COMMENTS AND COMMENT RESPONSES

From: Shree Dharasker <sdharasker@valleywater.org>
Sent: Wednesday, December 28, 2022 10:58:01 AM
To: kkeating@santaclaraca.gov <kkeating@santaclaraca.gov>; Hedy Koczwarra <Hkoczwarra@aspeneg.com>
Cc: Michael Martin <MichaelMartin@valleywater.org>
Subject: RE: SVP Homestead Substation Rebuild Project – Notice of Intent to Adopt an MND

Email: Homestead Substation Rebuild Project EIR Team

Figure B2-A: Walsh Substation view of concrete block wall with substation beyond.

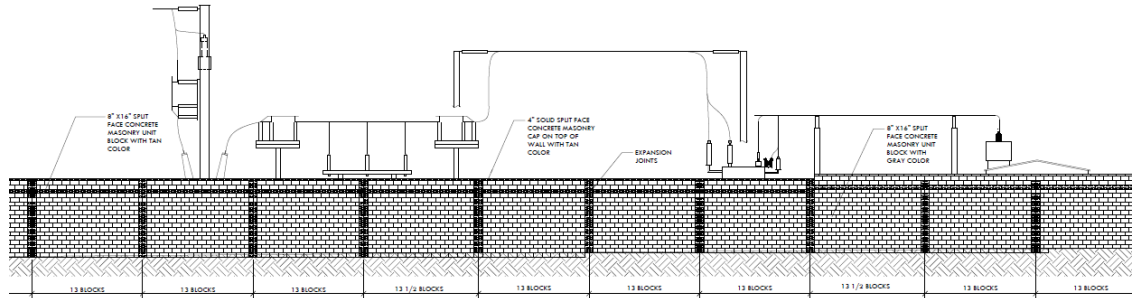
B2-2 The commenter thinks the IS/MND fails to present the visual impact of the height of new structures on the surrounding community and should include information on the height of structures and a plan view for consideration by the community. The commenter thinks that perspective views from four directions should be included along with photo mock-ups.

Views of the substation from publicly accessible areas are limited. The substation is an interior property surrounded by residential, commercial, and park land uses. It does not front on a public street. See IS/MND Figure 4.1 Homestead Substation Location. A plan view of the substation expansion is provided in IS/MND Figure 4.3 Homestead Substation Rebuild Layout. Final design will determine exact locations and dimensions. The image below in Figure B2-A for SVP's Walsh Substation illustrates the appearance of a concrete masonry unit (CMU) block wall with electrical equipment beyond. Switch gear and control enclosures and transformers are screened by the wall. The exact configuration and positioning of steel structures at the Homestead site will be determined in final design.

Views of the site from public locations are limited, the proposed wall would visually screen most of the site equipment and structures from view, and the site is already “industrial” in nature; therefore, visual impacts would be less than significant. However, SVP will enter into discussions with the apartment building management regarding the possibility of planting vegetation between the wall and the apartment parking area. Any vegetation would need to be of a type that would not damage the wall directly or by its roots.

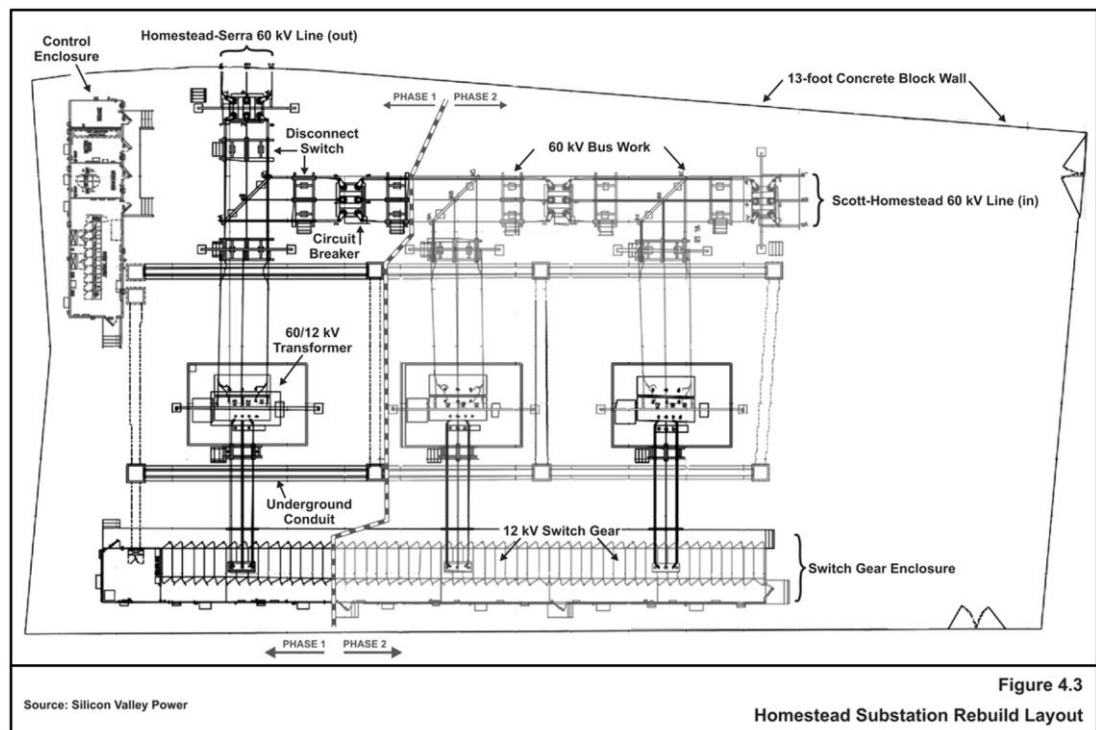
B2-3 The commenter believes that the proposed wall will have a profound visual impact and that trees should be used to enhance the aesthetics of the area and the proposed wall.

Final site plans and layout have not been developed for the Homestead Rebuild project. IS/MND Figure 4.3 Homestead Substation Rebuild Layout (reproduced below) shows the anticipated layout and location of equipment. The existing substation structures are located at approximately the site of what would be the eastern-most of the new transformers. The location of the gate shown in Figure B2-C above is indicated at the lower right of the drawing. The apartment property extends approximately one-third of the distance along the substation property to the left of the gate

The wall would provide a uniform visual form screening much of the substation's equipment from views at ground level. A few second story apartments have existing views of the substation, as shown in Figure B2-D above, a situation that would remain. The removal of the existing wood poles would improve the view. Structural steel framing that would support the transformers, and lines to them, would be visible above the wall. The new steel structures would be similar in nature to the existing substation visual effect.
